Notice of Allowability

10/688,534

Arnel C. Lavarias

FIG. 12

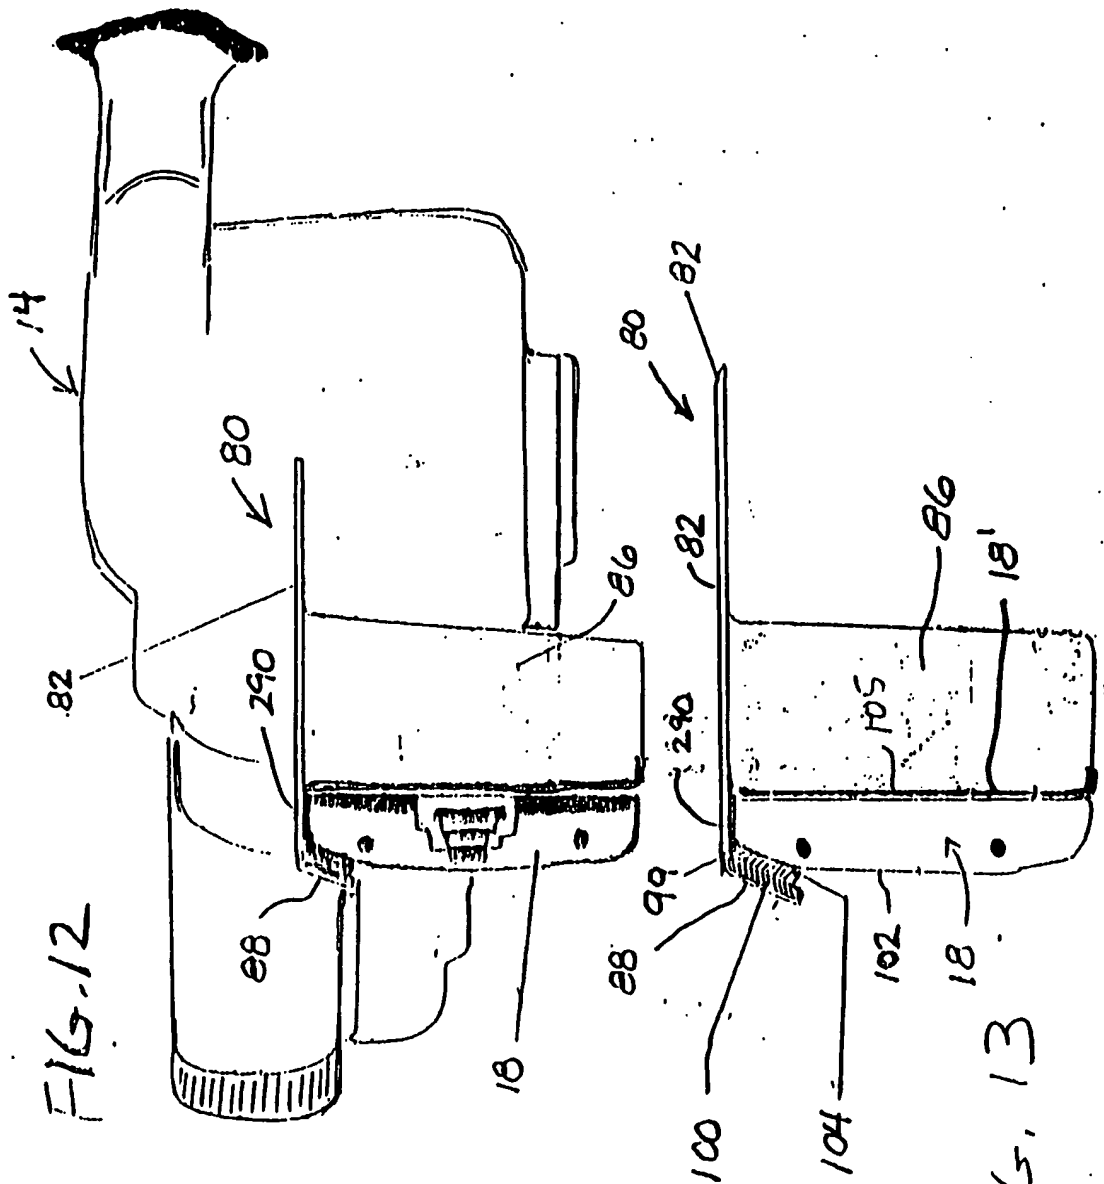
Figures 1-20- Lines, numbers, and letters are not uniformly thick and well defined, clean, durable, and black (poor line quality). See 37 CFR 1.84(i).

Corrected drawing sheets in compliance with 37 CFR 1.121(d) are required in reply to the Office action to avoid abandonment of the application. Any amended replacement drawing sheet should include all of the figures appearing on the immediate prior version of the sheet, even if only one figure is being amended. The figure or figure number of an amended drawing should not be labeled as "amended." If a drawing figure is to be canceled, the appropriate figure must be removed from the replacement sheet, and where necessary, the remaining figures must be renumbered and appropriate changes made to the brief description of the several views of the drawings for consistency. Additional replacement sheets may be necessary to show the renumbering of the remaining figures. Each drawing sheet submitted after the filing date of an application must be labeled in the top margin as either "Replacement Sheet" or "New Sheet" pursuant to 37 CFR 1.121(d).
